Thor Motor Coach Technical Service Bulletin

TSB #	TSB 26-05		
Description/Title:	DC/DC Charger wiring		
Affected Product Line(s):	Certain model year 2026-2027 Eddie Bauer Van, Palladium, Sanctuary, Talavera, Tranquility		
Service Campaign # :	RC000342		
Codes:	Inspect Only: TMCTS80250U Inspect with Repair: TMCTS80250J	Document Date:	8/31/2026
Time Allowed:	Inspect Only: 0.3 Inspect with Repair: 0.5	Document Revision:	A

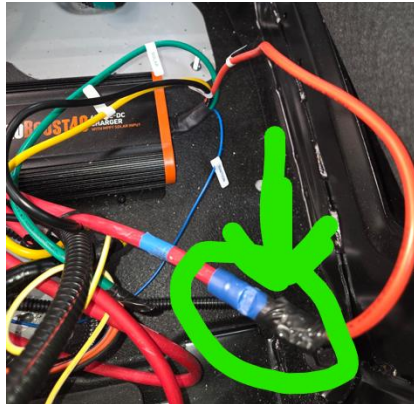
It has been discovered the DC/DC Charger may have been wired backwards. If the charger wires are reversed, it is preventing the chassis alternator from charging the house batteries.

1. Locate the DC/DC Charger under the passenger seat using the access door on the side of the pedestal.

2. Locate the Red (may appear Orange) & Yellow wires leading into the DC/DC Charger.
3. The Yellow lead wire is an input from the chassis battery and is connected to a 6 gauge Red wire.
4. The Red (may appear Orange) is an output to the house battery and is connected to a 6 gauge Red wire.
5. Note the voltage at both chassis and house battery prior to doing anything. Use this as a reference in the following criteria:
 - a. shore power cord unplugged
 - b. house disconnect switch in the OFF position
 - c. chassis engine idling for roughly 2 minutes
 - i. test the voltage where the Yellow and 6 gauge Red wire are connected. It should be roughly 13+ Volts.

6. If the chassis battery voltage is discovered on the Red (may appear Orange) wire of the DC/DC Charger and not on the required Yellow, the 6 gauge Red wires connected to the Yellow and Red (may appear Orange) will need to be swapped.
 - a. If the wires required to be swapped, repeat step 5 to ensure accuracy.
